SUBDIVISION REVIEW SHEET**CASE NO.:** C8-2020-00038.0A**COMMISSION DATE:** April 28, 2020**SUBDIVISION NAME:** Charro Estates**ADDRESS:** 694 Mesa Drive**OWNER/APPLICANT:** Jocelyn Fuentes**AGENT:** ATX Permit & Consulting, LLC (Lila Nelson)**EXISTING ZONING:** None**JURISDICTION:** 5-Mile ETJ**GRIDS:** S-9**COUNTY:** Bastrop**AREA:** 5.46 acres**LOT(S):** 5**WATERSHED:** Cedar Creek**DISTRICT:** N/A**PROPOSED LAND USE:** Single Family

CASE NUMBER: **C8-2020-0038.0A**
REVISION #: **00** UPDATE: **U0**
CASE MANAGER: Sylvia Limon PHONE #: 512-974-2767

PROJECT NAME: **Charro Estates** (W/R C8-2019-0031.0A)
LOCATION: 694 MESA DR

CHARRO ESTATES SUBDIVISION RESUBDIVISION PLAT OF LOT 15

SHEET 02
OF 11

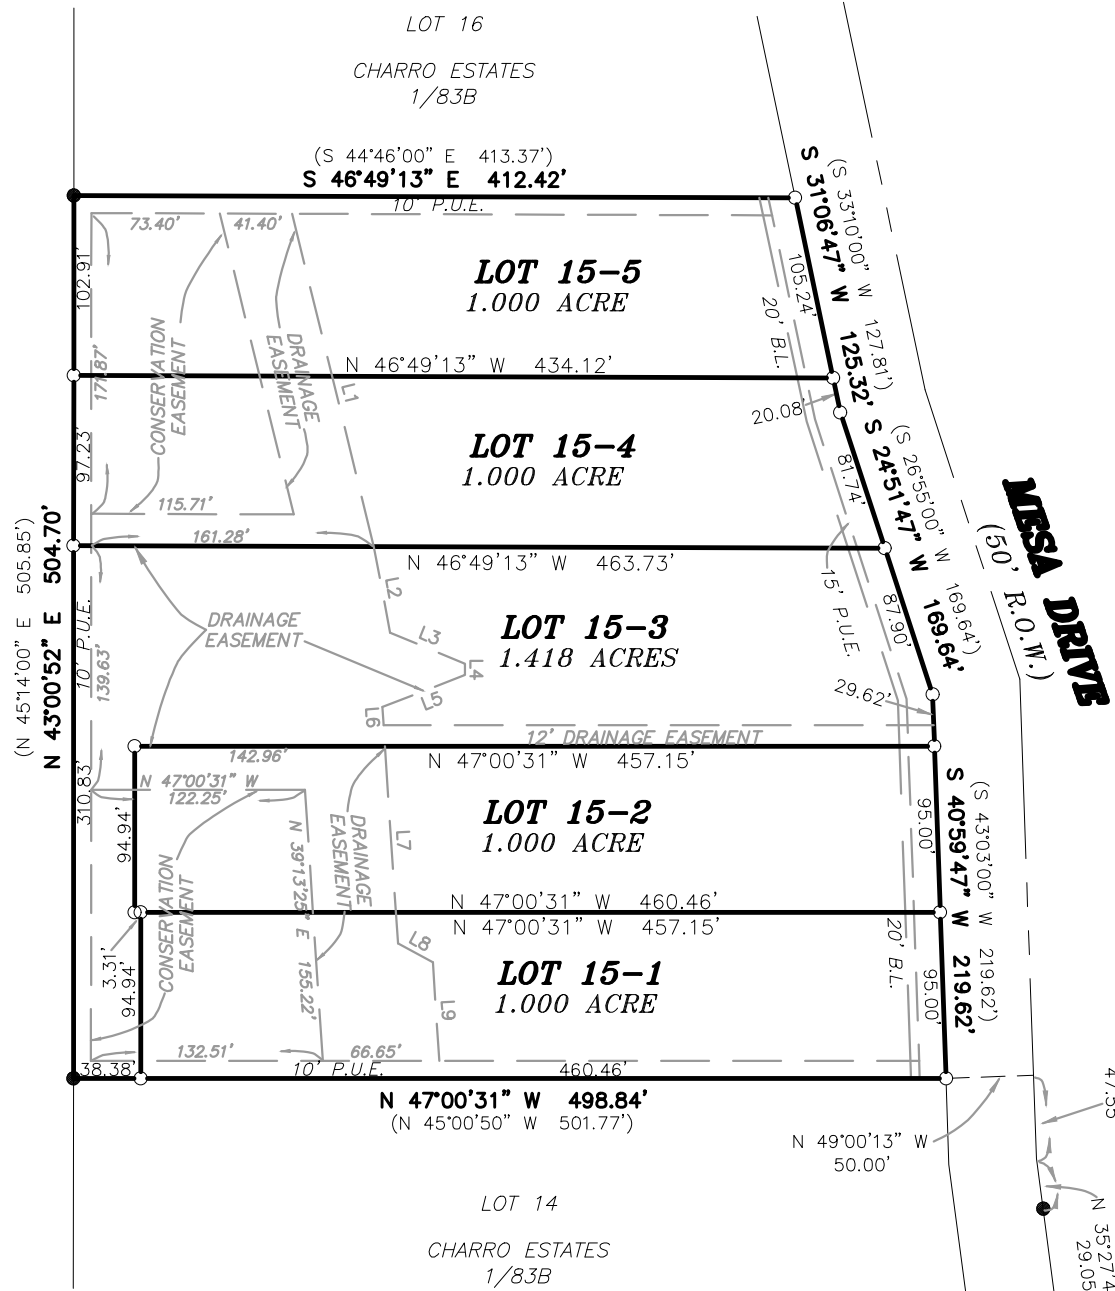
PR 2: Update note 11 on the plat:

A fee-in-lieu of parkland dedication and park development has been paid for 4 residences. No fee was charged for the existing residence

- SR 3. If the drainage easement is being created with the plat, be sure show survey boundary information for the boundary of the easement. It appears there are not corresponding measurements for all of the boundary lines of the easement. [LDC 25-1-83]

- SR 4. Remove plat note number 2. This note is not applicable since City of Austin Water Utility will not be servicing this subdivision. [LDC 25-1-83]

- SR 6. Revise the City of Austin Commission approval block to appear as follows on the plat [LDC 25-1-83]:
ACCEPTED AND AUTHORIZED FOR RECORD BY THE LANDUSE COMMISSION OF THE
CITY OF AUSTIN, TEXAS, THIS, THE _____ DAY OF _____ 20__.
_____, CHAIR _____, SECRETARY
